## **MUSHROOM SUBSTRATE PLANT, MULGRAVE APPLICATION TO MODIFY APPROVALS FOR PROJECT AND CONCEPT PLAN (08\_0255 MOD 1) MODIFIED DIAGRAMS**

Two figures contained in the environmental assessment have been modified. The modified versions of Figure 2 – *Existing and Approved Development*, and Figure 6 – *Revised Staging Plan* are attached.

FIGURE 2 Existing and Approved Development

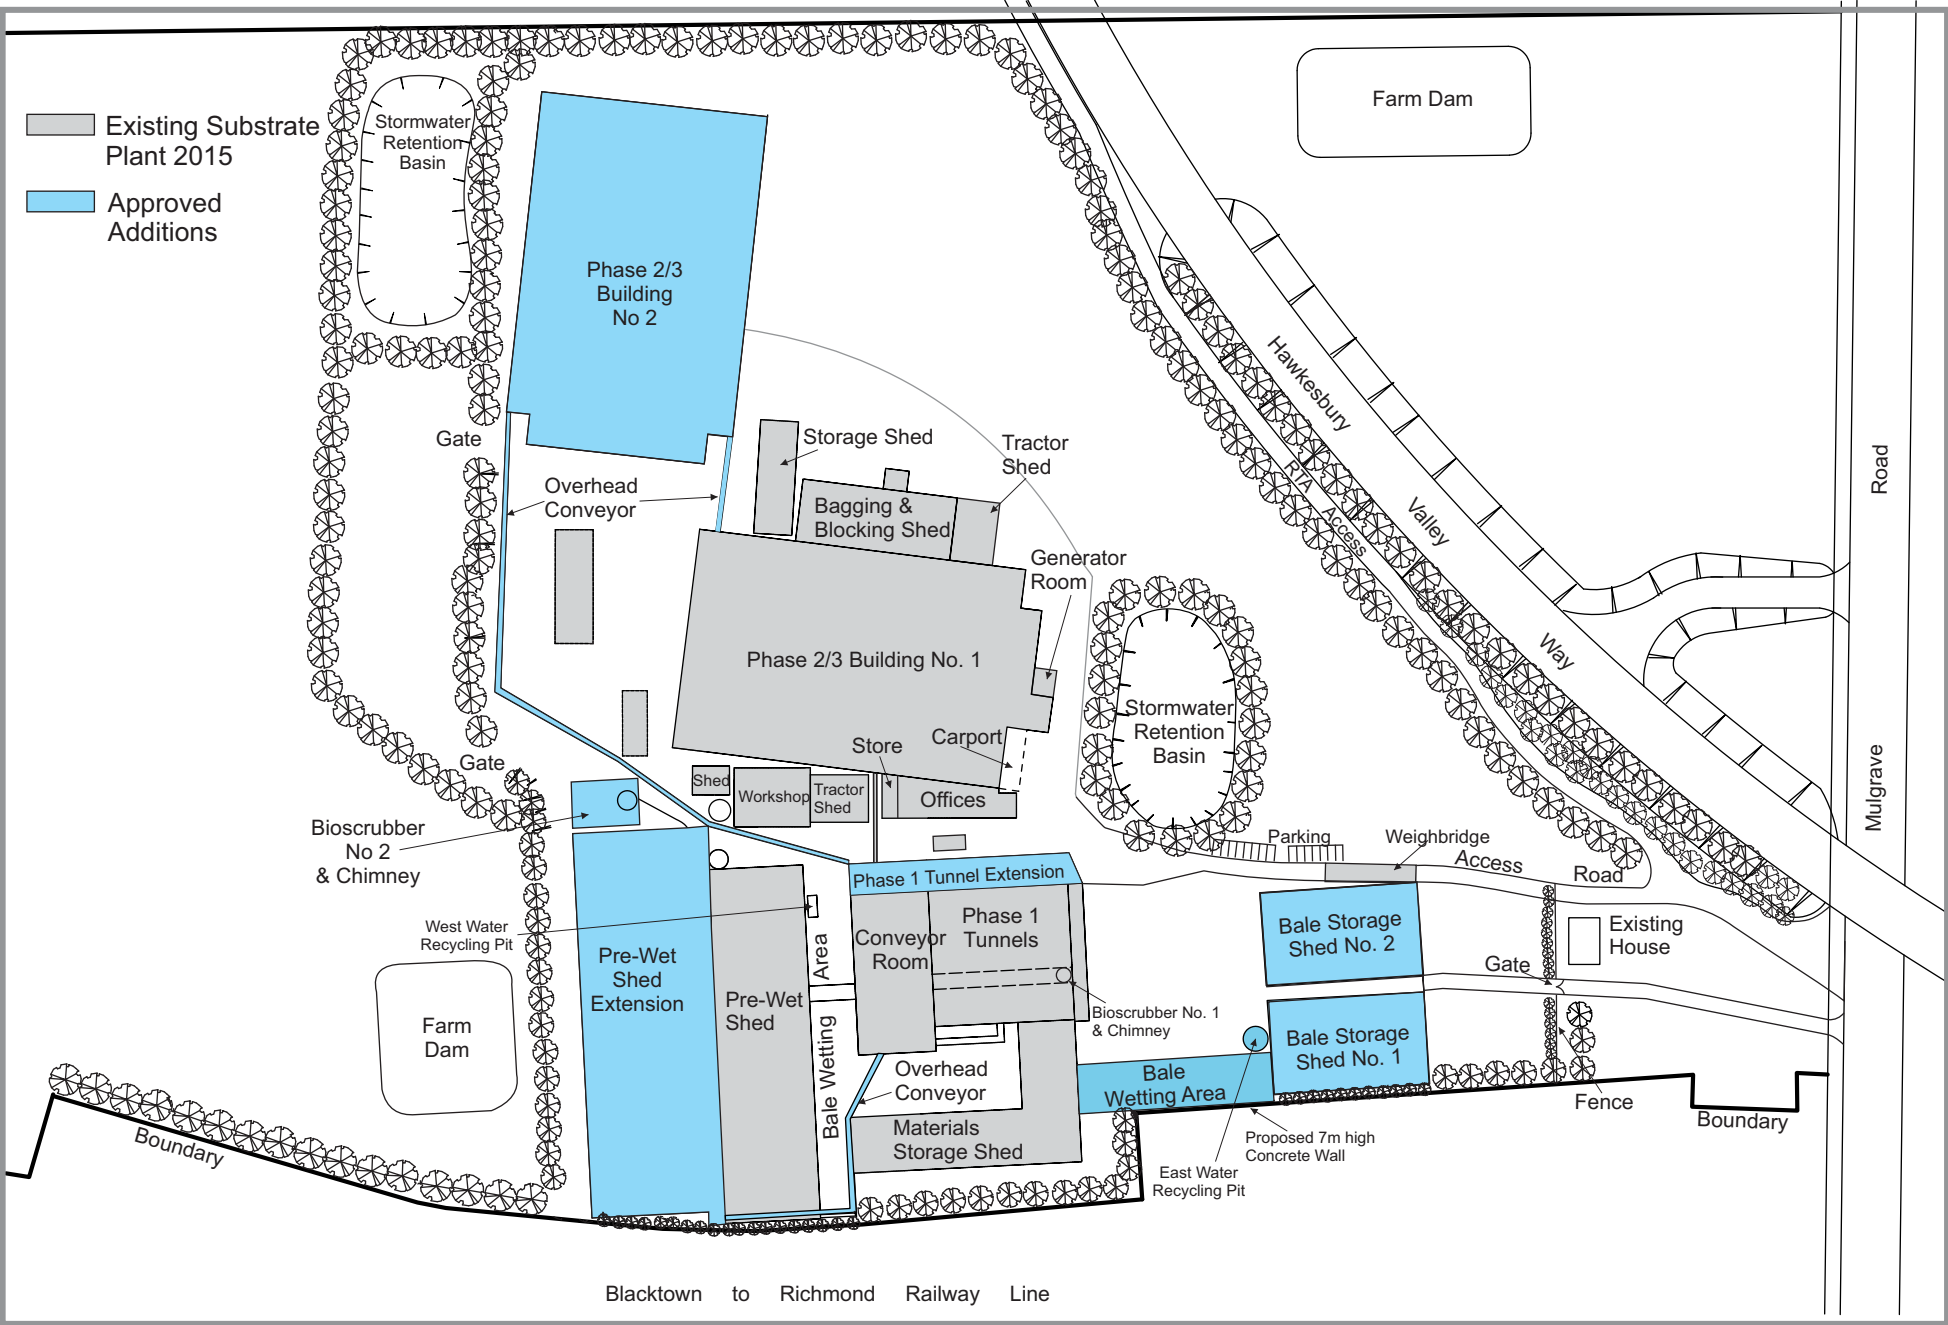
1. Identify the existing bale wetting area (requested by DoPE)

FIGURE 6 Revised Staging Plan

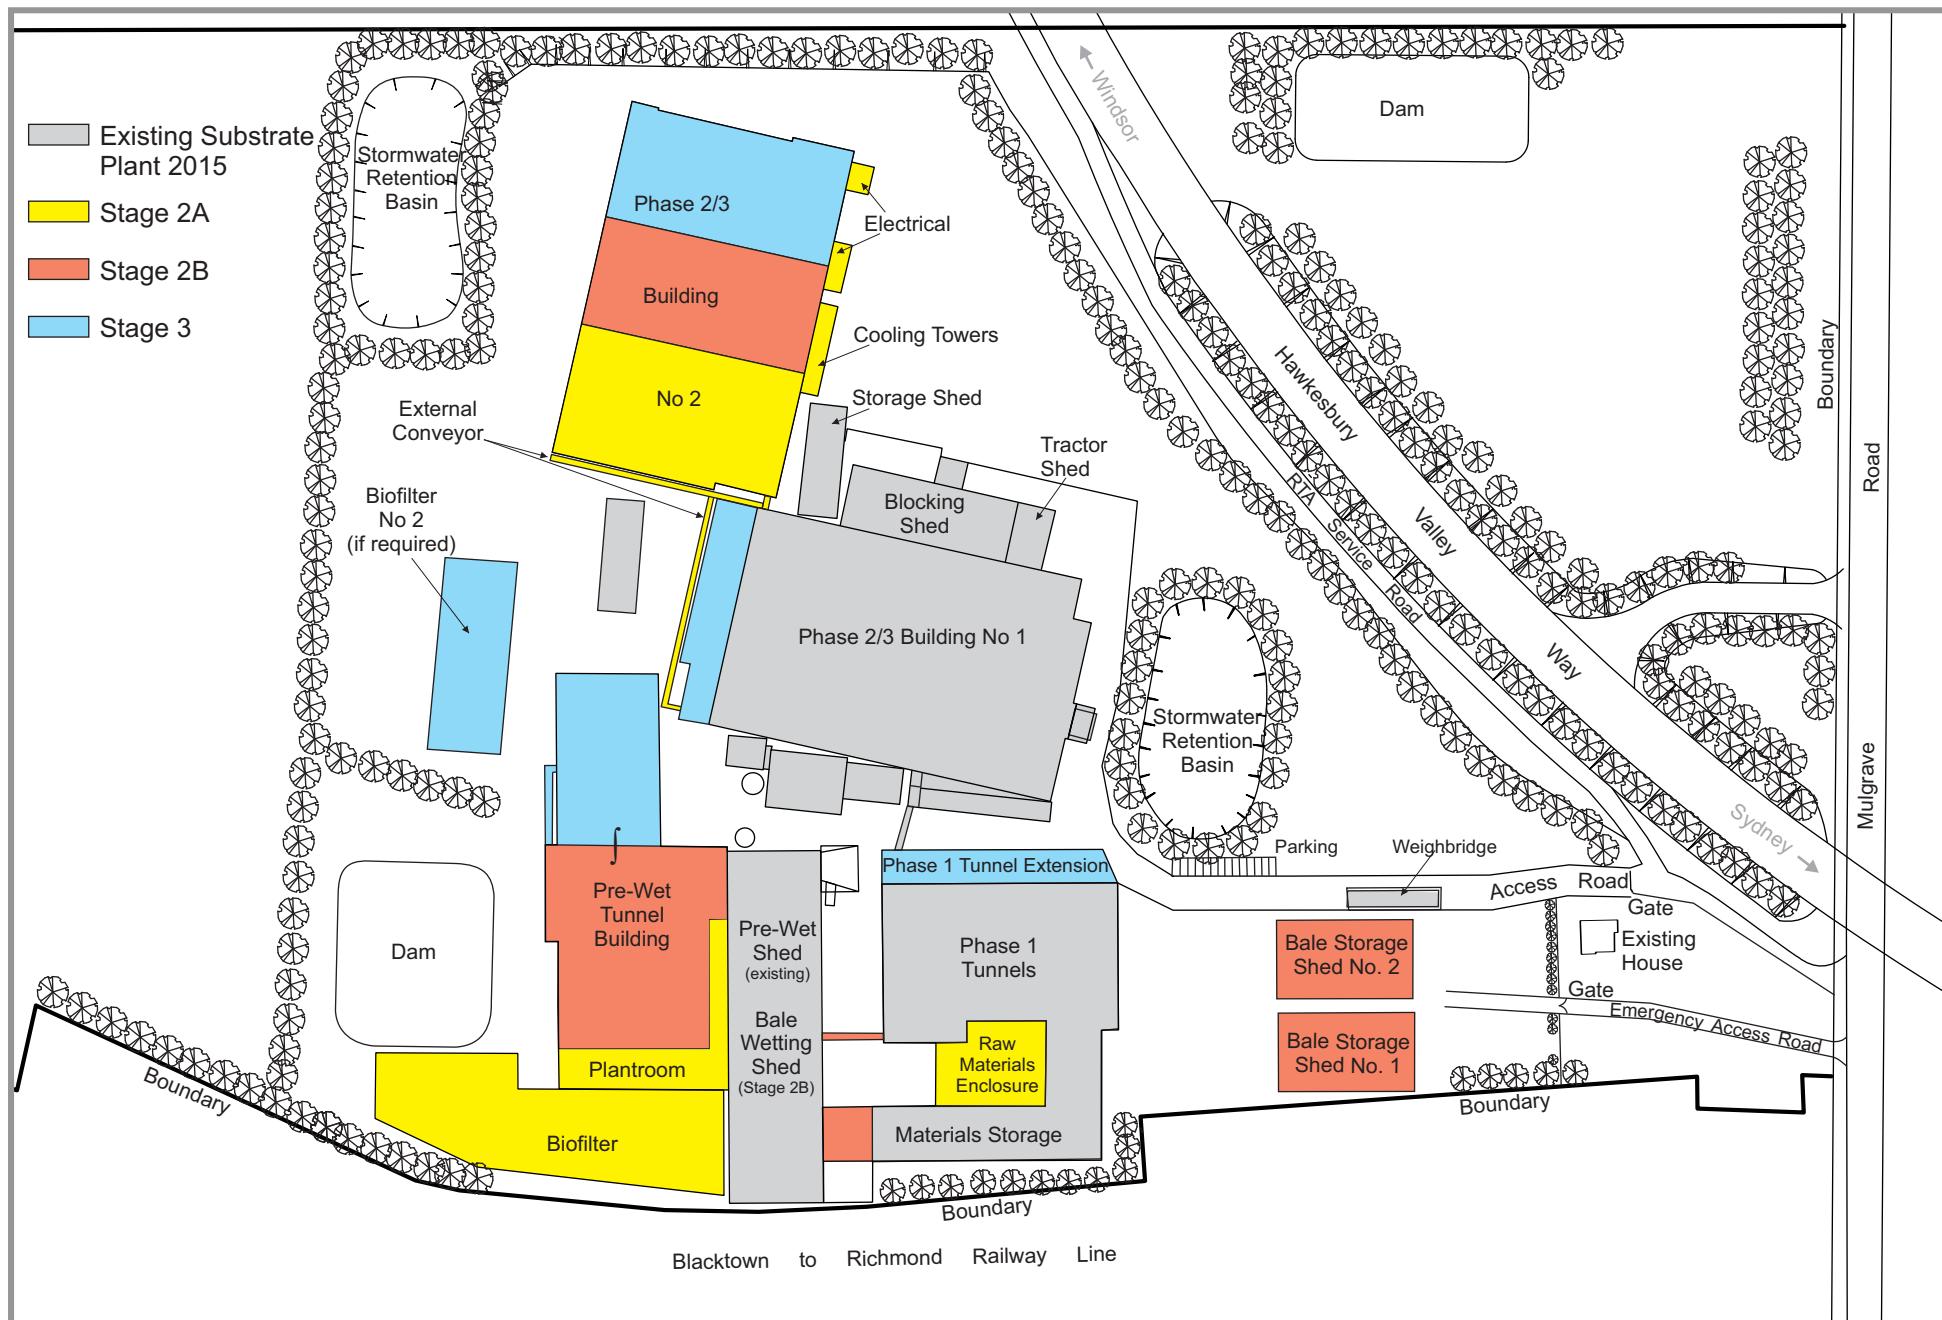
1. Show the location of all external conveyors (requested by DoPE)
2. Indicate the new use of the current pre-wet shed (requested by DoPE)
3. Advance the raw materials enclosure to Stage 2A (for emissions control)
4. Advance construction of some Phase 2/3 tunnels to Stages 2A or 2B (amended by Elf Farm Supplies)

The sequence of construction of Phase 2/3 tunnels has been amended by Elf Farm Supplies for the following reasons:

- the benefits of having a longer residence time for the product in Phase 2 and 3 processing as described in the EA will be achieved at an earlier point in time;
- completing some of the tunnels of the No 2 building allows part of the No 1 building to be taken off line for internal refurbishment including additional emission control equipment;
- The additional tunnels will be needed by the time production reaches the currently approved limit of 1600 tonnes per week.
- This work is far enough removed from the biofilter and plantroom installation that both projects can proceed simultaneously without significant interaction. The area will become busier when the pre-wet tunnels are under construction;
